SUBMISSION ON A RESOURCE CONSENT APPLICATION THAT IS SUBJECT TO LIMITED NOTIFICATION BY THE KAPITI COAST DISTRICT COUNCIL

Application Number:	RM190125
Applicant:	Housing New Zealand Ltd
Proposal:	To undertake a two lot residential subdivision that does not meet the shape factor, minimum and average lot sizes, requires consent for contaminants in soil and land use consent for the construction of two dwellings prior to the certification of the subdivision that do not meet the permitted activity standards for car parking, water demand management and accessory buildings encroaching the require yard setbacks
Legal Description(s):	Lot 62 DP 23300, 35 Kaitawa Crescent, Paraparaumu

Opposition to the RM190125 35 Kaitawa Crescent Paraparaumu

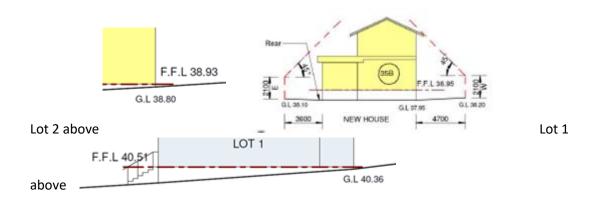
The foundation to ground clearance is wrong. The house height will need to be lifted, or the house position will need to be shifted, to comply with daylighting requirements. Please see the below copied diagrams from the RM190125 showing ground clearance for a concrete foundation, whereas the building consent plans are for a timber floor construction (shown to me on screen in council – I am still waiting on copies of the full working drawings, which I have requested from KCDC.)

- The house is close to touching the day lighting angle and the foundations are shown with base boards.

- As per the building code, the underside of the floor joist to the ground level needs to be a minimum of 450mm. (175mm minimum to the bottom of the cladding) the information provided shows ground level to the finished floor at 130mm for lot2 and lot one at 150mm both non-compliant, if site cuts are to be carried out to drop the ground level this will need to calculated and provided as part of the resource consent, this would need to include the sloping car part areas

- This is a sloping site- surface water needs to be redirected away from the foundations. Where is this information please?
- The below drawn images from the RM190125 are non-compliant and don't support timber floor clearances.
